MOTOROLA

FIELD SERVICE BULLETIN

FSB Number: **Preliminary** BJCCFSB2006-346
Author: Feng Joanna
Date: July 24, 2006
Total No. of Pages: 3
Subject: **V3i Keypad Heating_Wrong Capacitor Placed in EL Circuit**
Model Affected: GSM V3i
Level of Repair: 2

Figure 1: The wrong valued capacitor on the left looks very different from the truly 3300-pF capacitor on the right. The wrong valued part has a dark brown body that is thicker but narrower as compared with the 3300-pF capacitor having a light brown body.

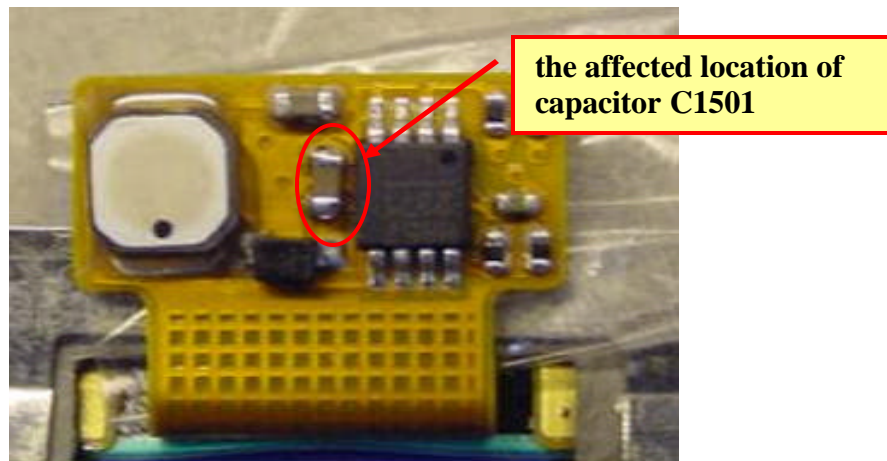
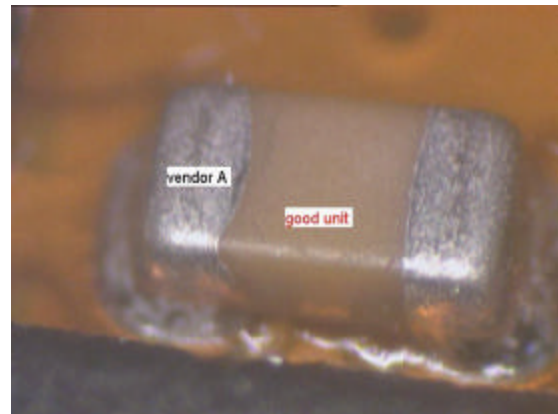
Service is aware of an issue, which has been identified in the analysis of V3i MOL returns. The symptom is high current drain at power supply and noticeable heat on the main keypad. It may finally cause the customer complaint of "Main Keypad, No/dim Backlight". The bypass capacitor C1501 in the EL circuit was found shorted.

The root cause is that a wrong valued capacitor was misplaced on the location of the capacitor C1501 (3300-pF) in the EL circuit. The failed Kflex is assembled by one of V3i Kflex suppliers, FAT (Foxconn Advanced Technology Inc). The affected Date Code is 1506 (= Week 15, Year 2006). Another supplier M-Flex is not affected.

Figure 2: FAT's Kflex after containment action

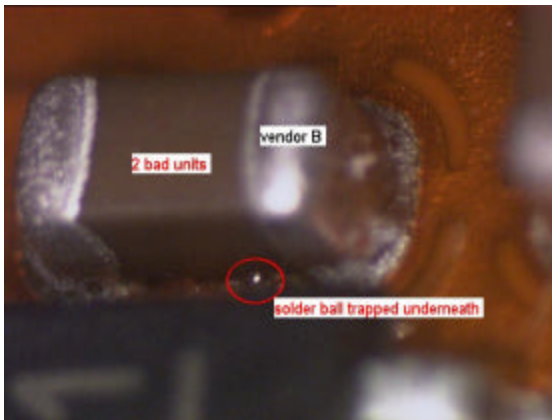
1. FAT started 100% manual inspection after C1501 and C1502 SMT processes to verify the corrective capacitors being mounting. Starting date: 7/11/06
2. MSE started 100% manual inspection by flip assembling line before k-flex is assembled. Starting date: 7/17/06 (Week 29, Year 2006)
3. 100% sorted k-flexes are identified by adding blue dots near the silk print. Starting date: 7/11/06

Part Identification: Currently there are two suppliers for the V3i Keypad flex: M-Flex and FAT, which have different ID numbers on the back of the Kflex.

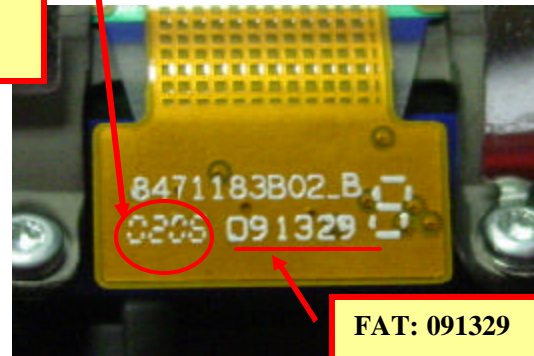
When servicing any V3i customer return with described issue, check the Kflex supplier and Date Code firstly (See information below for part identification). If it is FAT's with Date Code before 2906, and has no blue dot near the silk print, test the current drain at power supply:

2. Verify the current drain at power supply after phone display shows "Insert SIM";
3. If the current drain is larger than 0.2A, replace the Kflex (part No. 8471183B02).

Please purge existing inventory of FAT's Kflex with Date Code 1506. **P/N(s):** 8471183B02
